# M7

750cc  
PrintArea

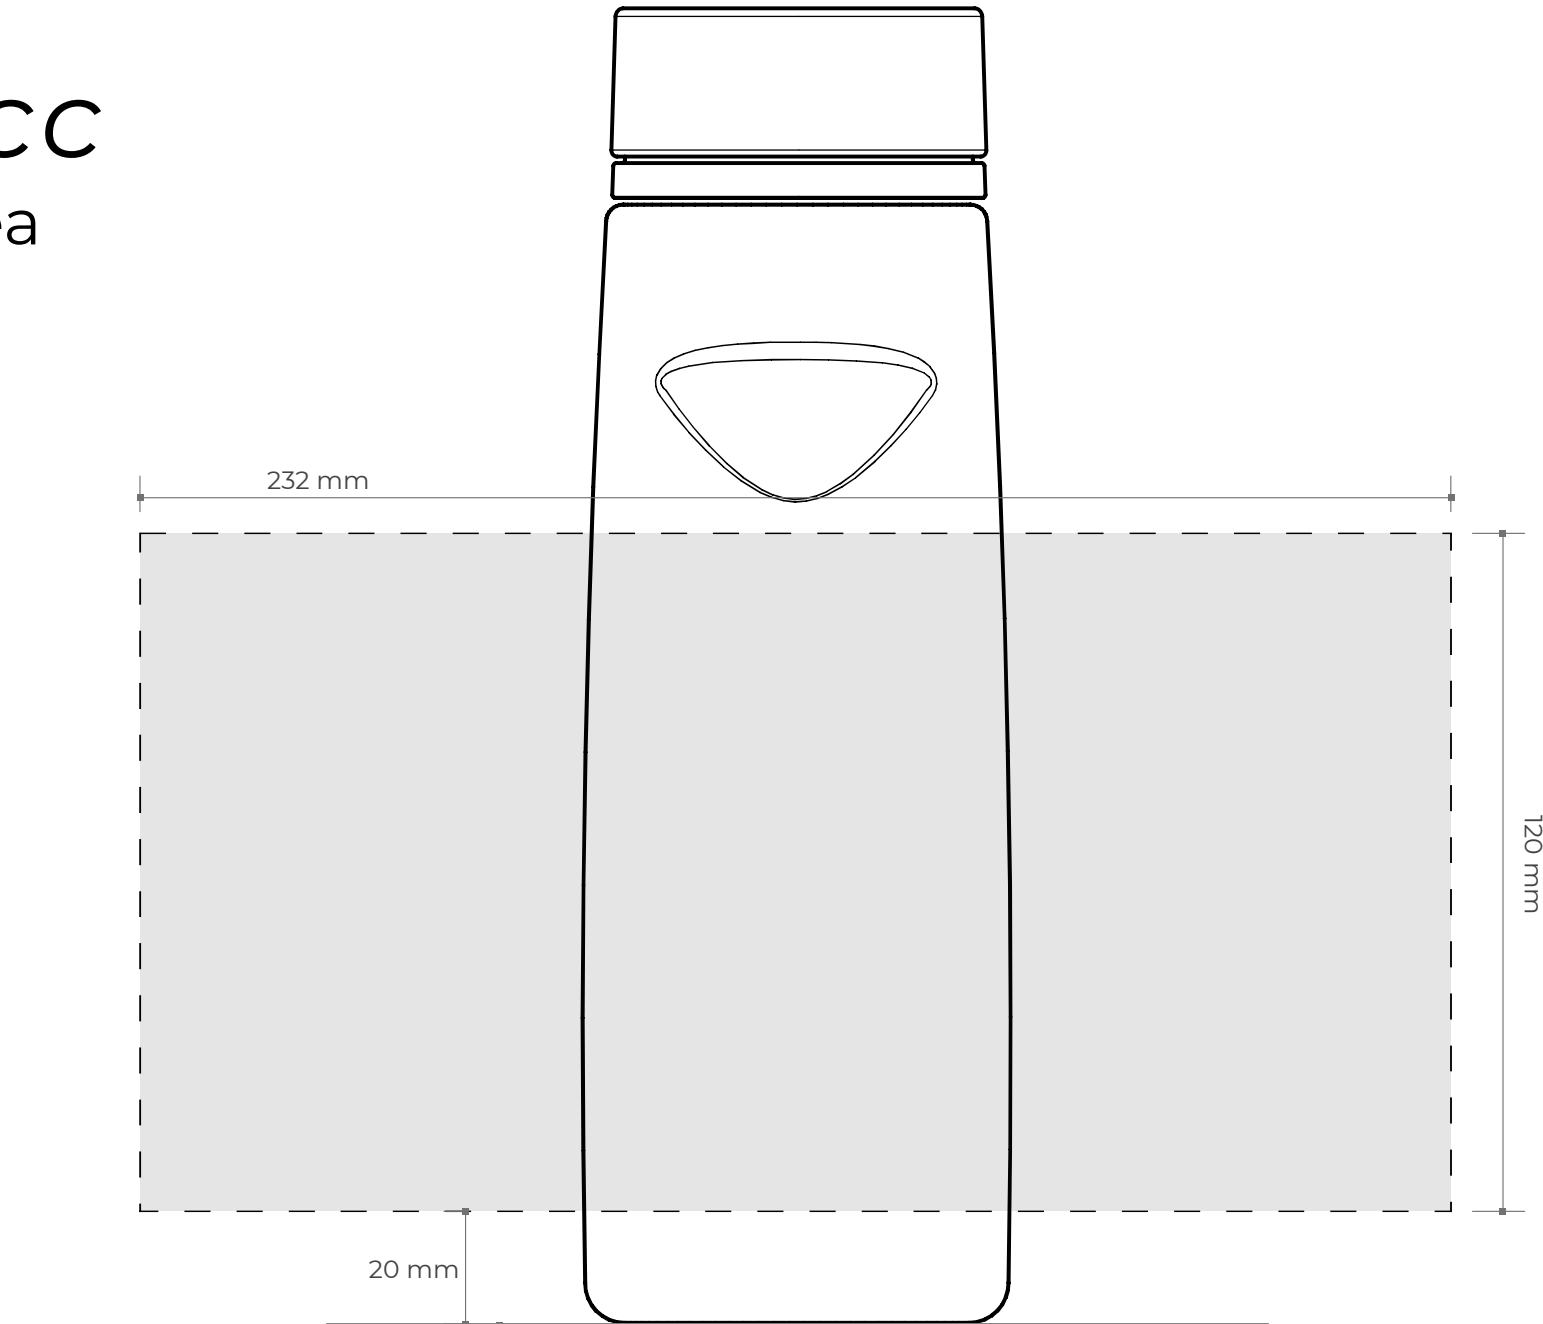
*The impression can not close on the circumference of the bottle:  
it's necessary to consider a non-printable area (approx. 0,8 cm width)*
